SERVICE BULLETIN

Subject: LCD Console & LCD Power Supply Rework

Bulletin No. SB07-1

Figure 2

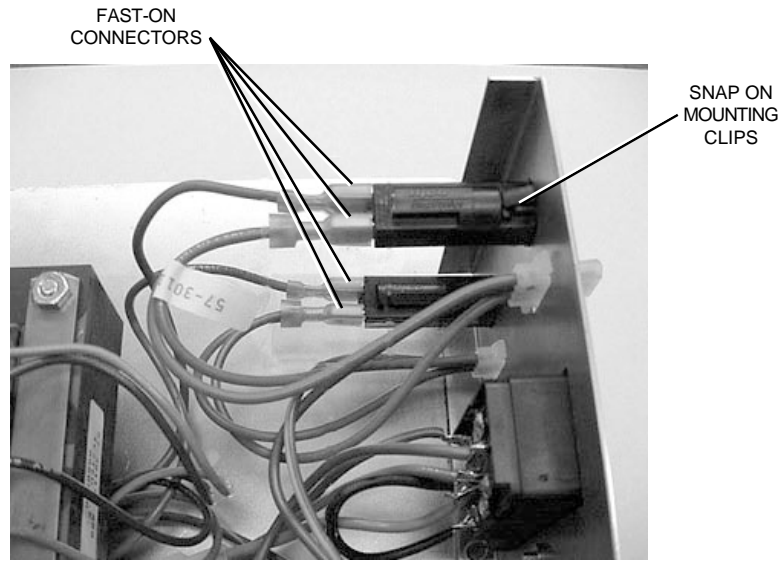
1. Remove the four screws from power supply and remove the power supply cover.
2. Disconnect the Fast-On connectors from existing 2-amp circuit breaker. *Refer to Figure 2.*

3. While pressing the circuit breaker plastic mounting clips, remove the existing 2-amp circuit breaker from the enclosure. Refer to Figure 2.

Figure 3

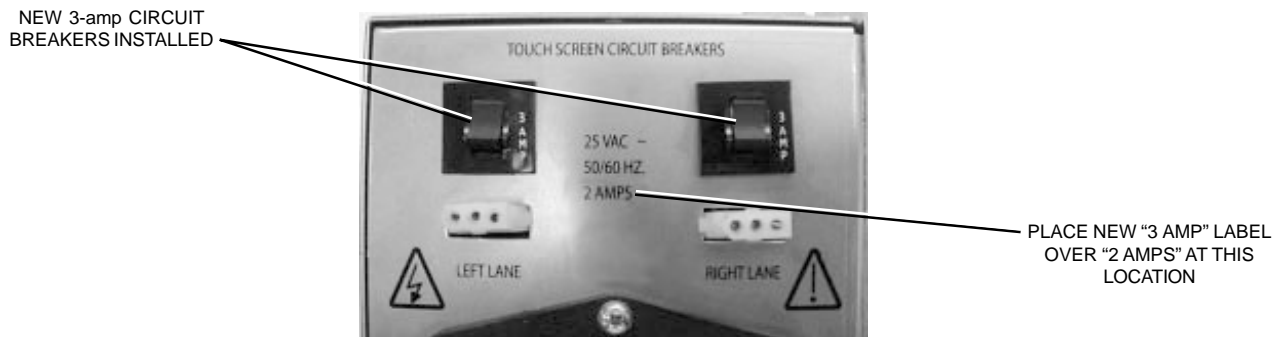
4. Install the new 3-amp circuit breaker and reconnect the Fast-On connectors. Keep the rotation of the circuit breaker correct. Refer to Figure 3.
5. Repeat the procedure for the second circuit breaker.
6. Reinstall the power supply cover.
7. Place the new “3 AMPS” label over the existing “2 AMPS” silk screened on the enclosure. Refer to Figure 3.

Figure 10

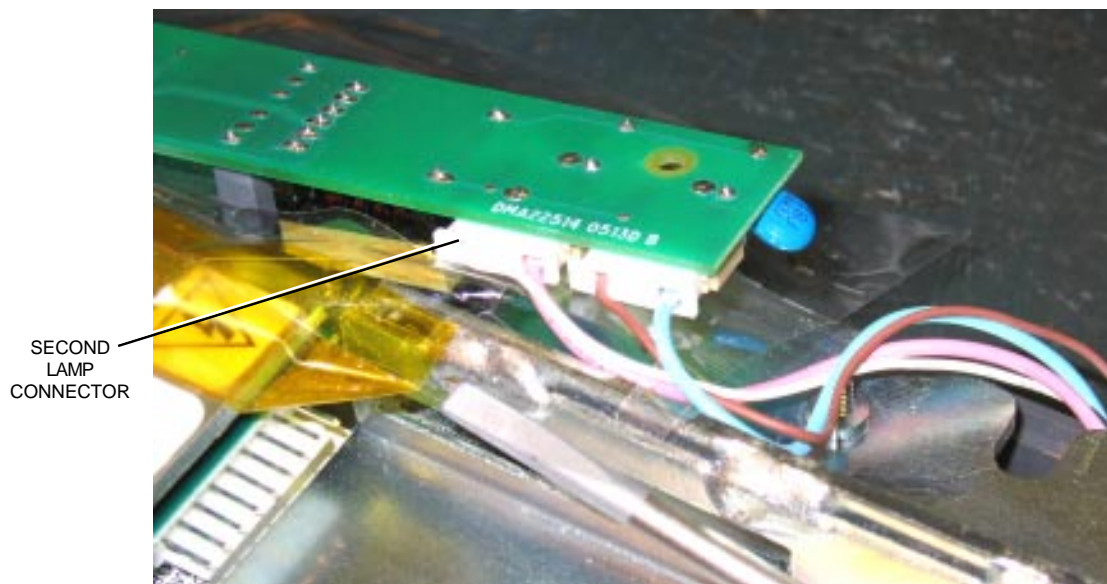
6. Connect the second lamp connector to the Inverter PCB. The lamp connector must go through the metal slot and plug into the inverter PCB. Refer to Figure 10.

Figure 12

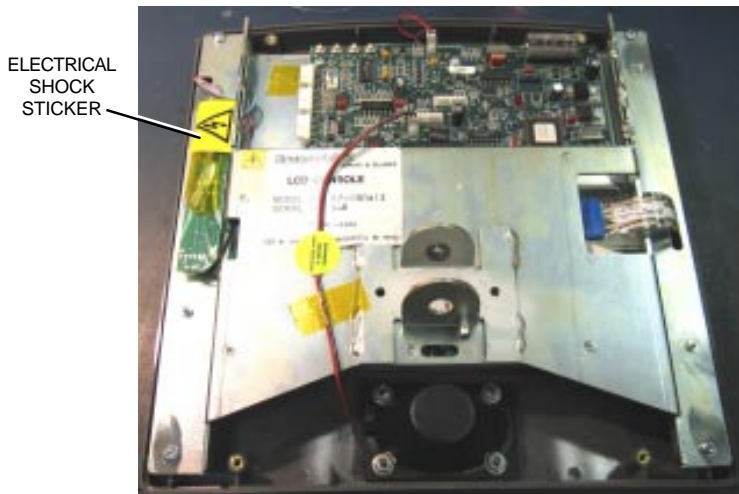
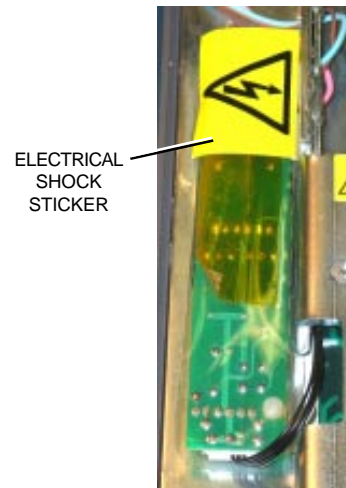
9. To prevent and indicate an electrical shock hazard, the electrical shock hazard sticker, part number 11-681156-000, included with this Bulletin, must be placed on the cellophane in the appropriate area as shown in *Figures 12 and 13.*
